Serial: NPD-NRC-2010-073
September 15, 2010

**SHEARON HARRIS NUCLEAR POWER PLANT, UNITS 2 AND 3
DOCKET NOS. 52-022 AND 52-023
RESPONSE TO SUPPLEMENTAL REQUEST FOR ADDITIONAL INFORMATION
CONCERNING HYDROLOGY CALCULATIONS IN SUPPORT OF A TRITIUM ANALYSIS**

**Shearon Harris Nuclear Power Plant Units 2 and 3
Response to NRC Supplemental Request for Additional Information Concerning
Hydrology Calculations in Support of a Tritium Analysis for the Combined License
Application, dated August 20, 2010**

Figure 1
Depth Profile of Tritium Concentrations

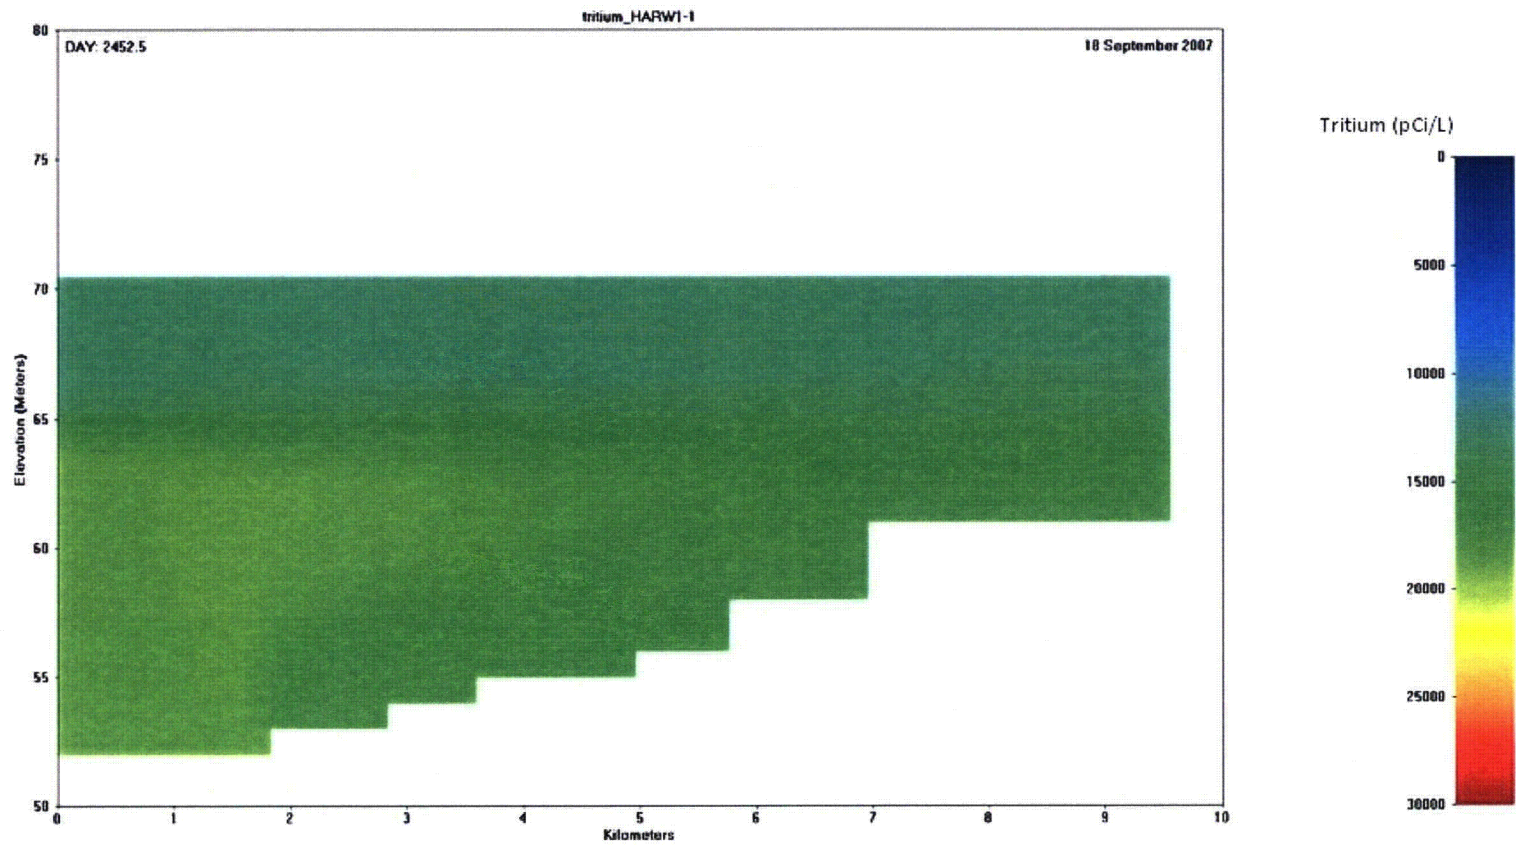
Provide the native files for the model CE-QUAL-W2 for the tritium analysis of Harris Reservoir as discussed in the calculation package HAR-338884- TMEM-122, a table of input parameters and their values which were used for conducting the tritium analysis using the model CE-QUAL-W2, and the model segment and layer numbers from which the results were extracted.

The results shown in HAR-338884-TMEM-122 are from the 1-meter surface layer closest to the Main Dam (Segment 13). Review of the evaluations performed in support of the Western Wake WRF study and the tritium modeling results indicated that this segment had the highest concentration of water quality constituents because of flow patterns and stratification of the reservoir in the summer. When the reservoir has stratified, tritium concentrations become fairly uniformly distributed in the volume above and the volume below the thermocline.

Tritium concentrations can build up below the thermocline during the summer resulting in concentrations that are higher than in the surface layer (See Figure 1, *Depth Profile of Tritium Concentrations*), however, the thermocline varies from approximately 5 to 10 meters below the surface. For this reason, the concentrations in the water volume above the thermocline are most relevant to primary contact concerns. Drinking water withdrawals are also above the thermocline and in one of the tributary arms of the reservoir, distant from the main dam. Reservoir turnover occurs each fall, distributing the accumulated tritium load throughout the entire water column.

On average, the tritium concentrations below the thermocline are 20 percent higher than above the thermocline. Review of the model predictions show that concentrations reach their highest level in the elevation range of 180 to 195 feet NGVD29. Table 2 presents the annual average and total average tritium concentrations for the simulation period (2001 to 2008) in the surface layer and at 187 feet NGVD29.

The allowable total body dose calculation of 4 millirems per year (mrem/yr) is based on an annual average concentration of 20,000 picocuries per liter (pCi/L). As shown in Table 2, the annual averages below the thermocline remain below 20,000 pCi/L even during drought

periods, such as 2007 to 2008, when reservoir inflows were limited. These annual averages support the conclusion that tritium levels are within acceptable levels at all locations within the reservoir.
